**EUROPEAN PRESSURISED REACTOR AT OLKILUOTO 3,
FINLAND**

FINNISH RADIATION & NUCLEAR SAFETY AUTHORITY (STUK) ASSESSMENT

CLIENT: GREENPEACE INTERNATIONAL

REPORT REF NO R3123-A2

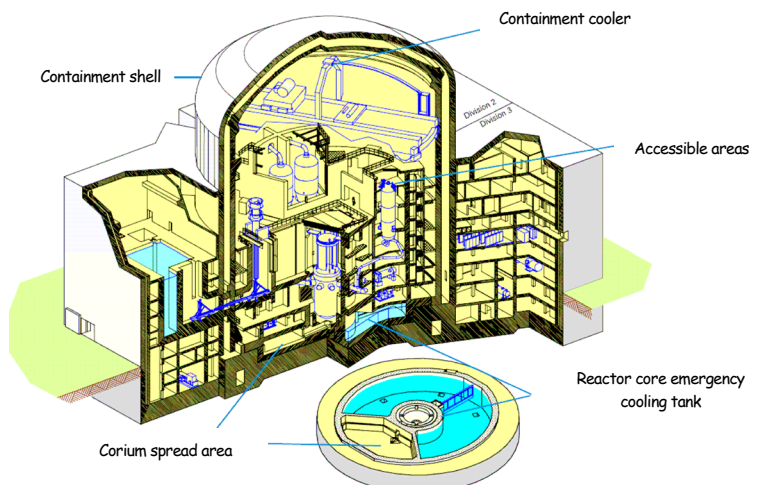
Radiation Dose Exposure Limits: The regulatory approach to minimising radiation dose exposure to members of public is not clearly presented in the PSARIR and the distinction between the *Design Basis* and *Severe* accidents is somewhat ambiguous.

- The permissible radiation dose exposures referred to in the PSARIR do not seem to directly relate to the emergency ratings (*'site emergency'*, *'emergency standby'* etc) specified in YVL guide,⁴³ nor indeed how and if these are to trigger the off-site emergency response plans as required under the European Council Directive 96/29/Euratom.⁴⁴

- The 3-month delay before the long term dose exposure commences is not at all clearly related in the PSARIR and, as it is explained,⁴⁵ it seems to be nothing more than a ruse to separate short and long term exposures most probably to the same critical groups of individuals.

- The definition of the 100TBq Cs-137 equivalent release does not have a logical derivation, particularly applied to EPR with its large fuel core, 4,300MW thermal rating and (planned) high fuel burn-up of 60GWd/T. The Cs-137 fuel inventory would be at least 3.10⁵TBq so the adopted 100TBq release represents a very small Cs-137 release fraction of 0.033%. Applied to the degraded core accident scenario, which is probably assumed to be the worst-case severe accident,^{46,47} the potential EPR release would be well beyond the magnitude of the gradual release defined by YVL 2.2.⁴⁸
